AGENDA

President and Board of Trustees
Village of Arlington Heights
Board Room

May 7, 2018

Figure: 7

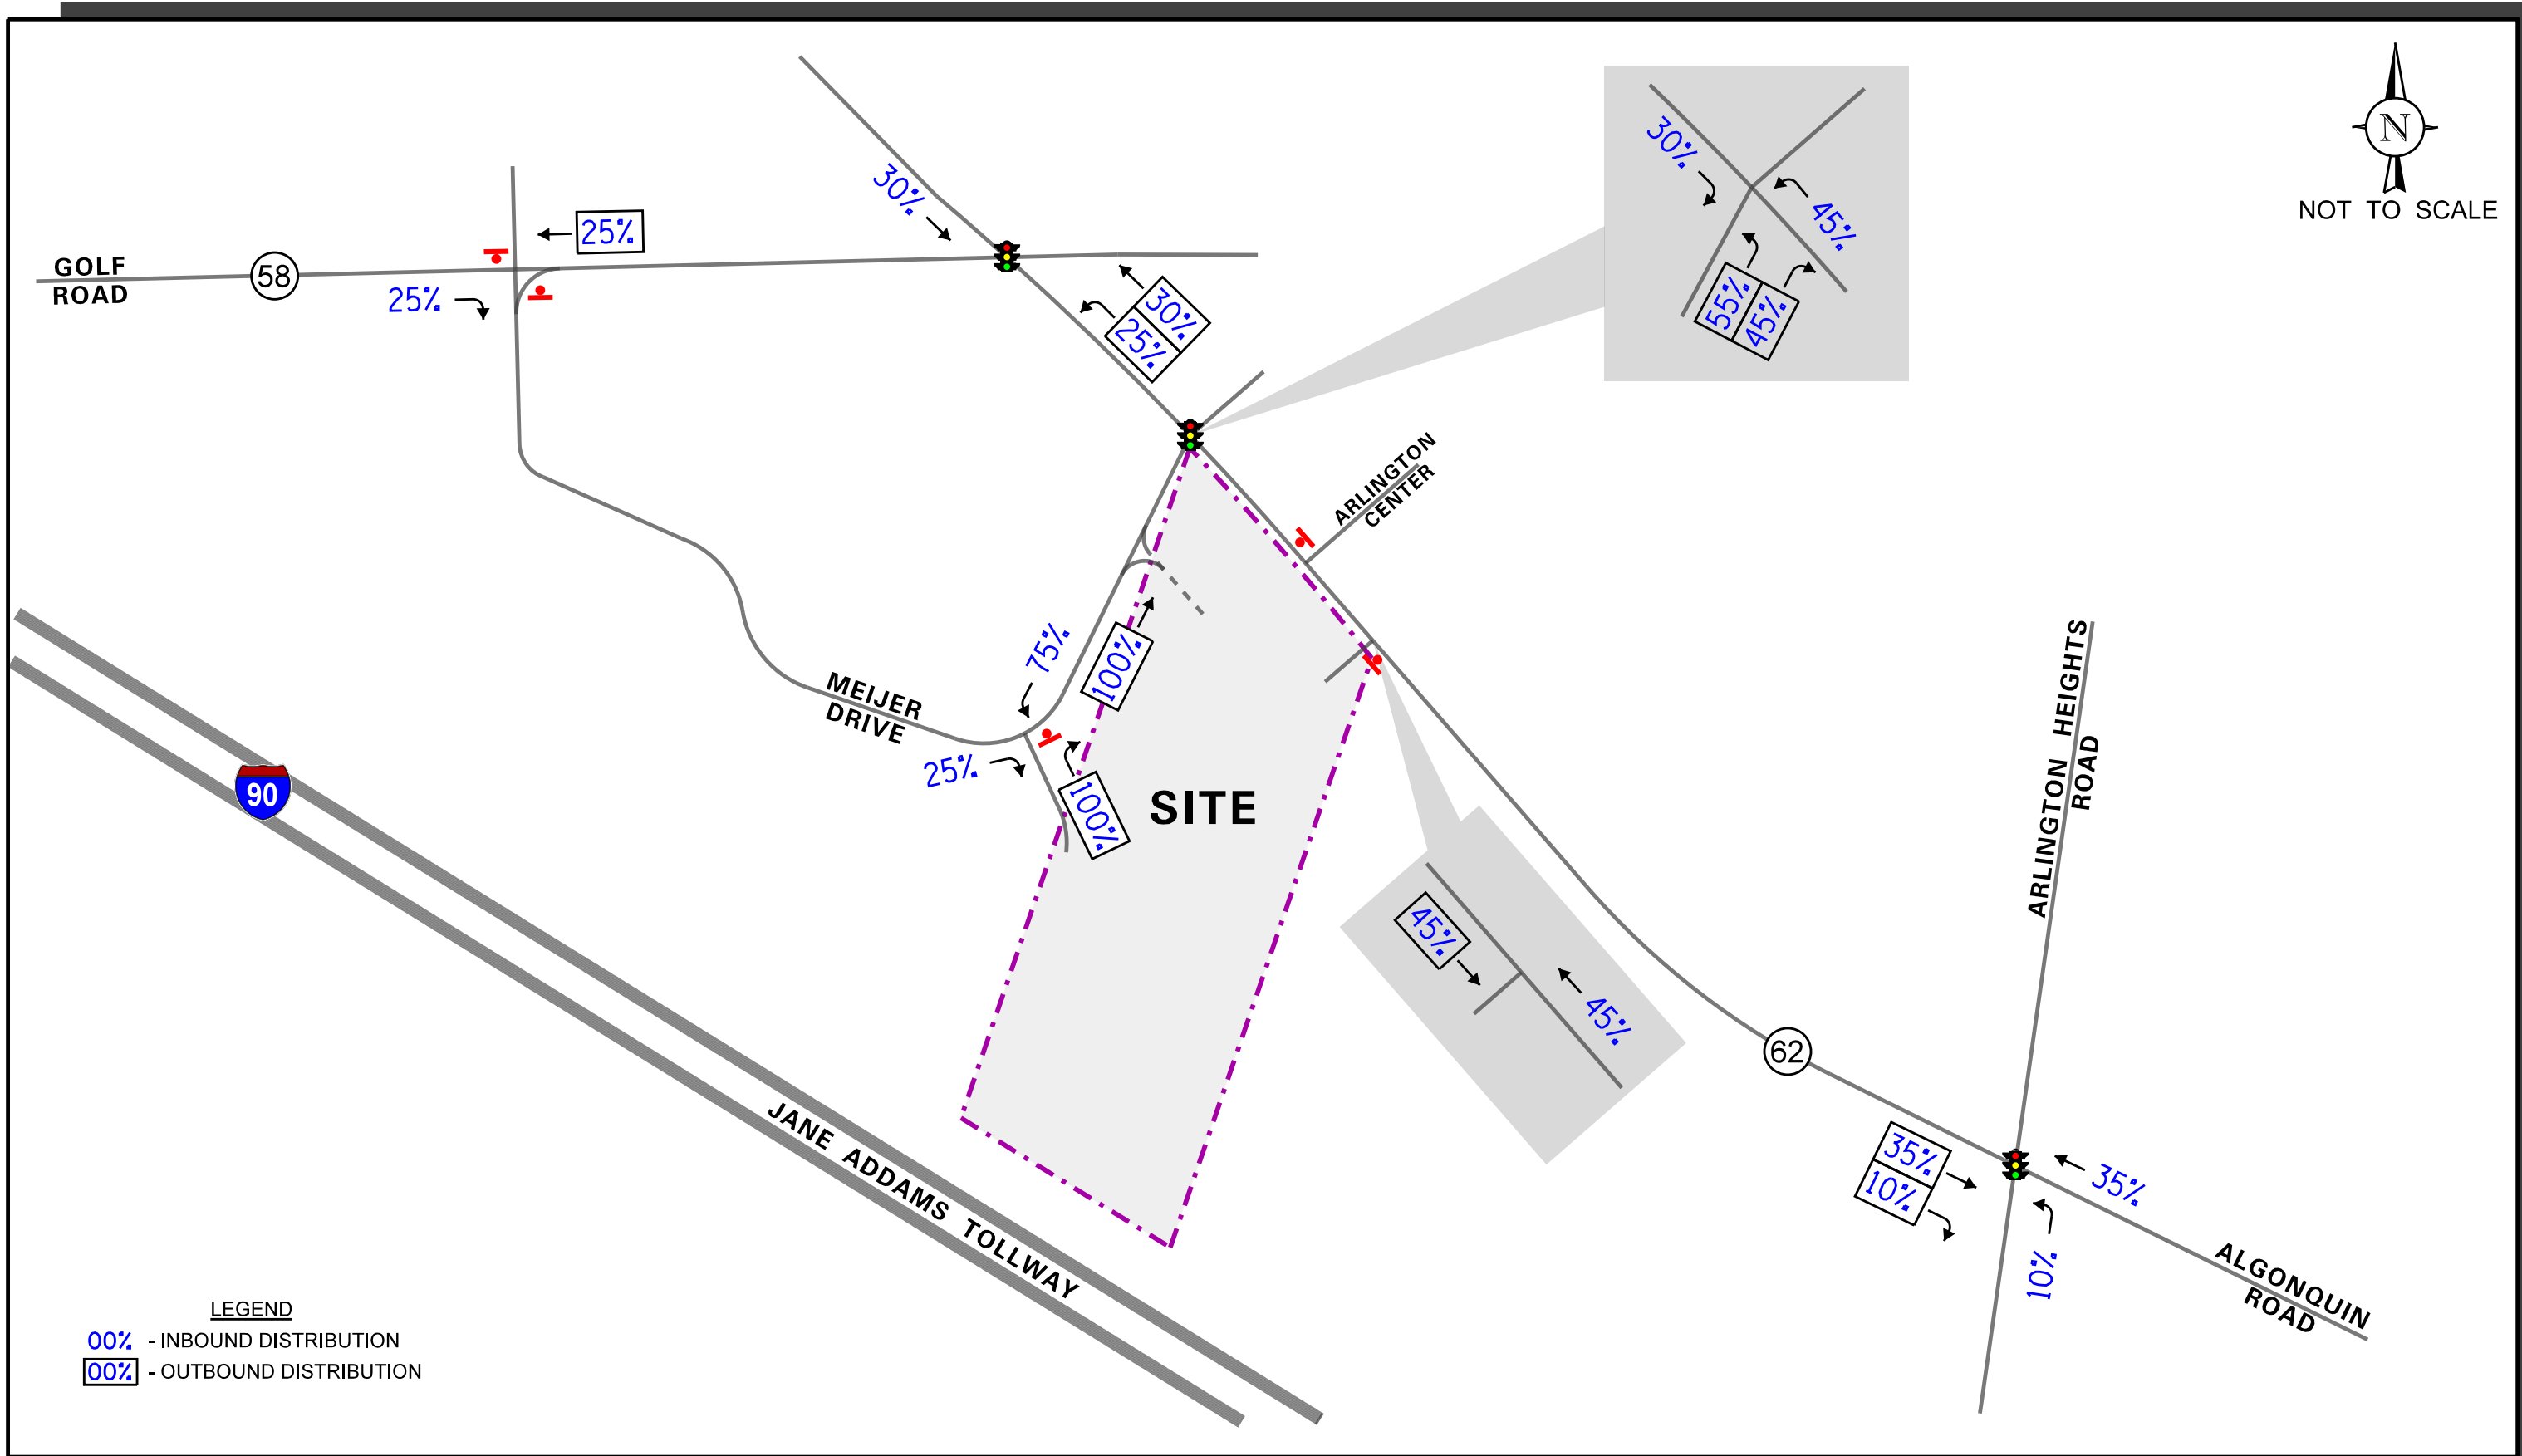
1. The heavy vehicle directional distribution shown on Figure 7 for the right turn onto Meijer Drive via IL Route 58 (Golf Road) seems high at 25%. Based on our brief observation period on a weekday in the mid-morning, several semi-trucks were observed using the traffic signal at IL Route 62 (Algonquin Road) and Meijer Drive. Site truck access along Meijer Drive via IL Route 58 (Golf Road) should be discouraged or restricted as that portion of Meijer Drive is winding and has many driveway access points. By contrast, the segment of Meijer Drive via IL Route 62 (Algonquin Road) is relatively straight and provides easy access to the site.
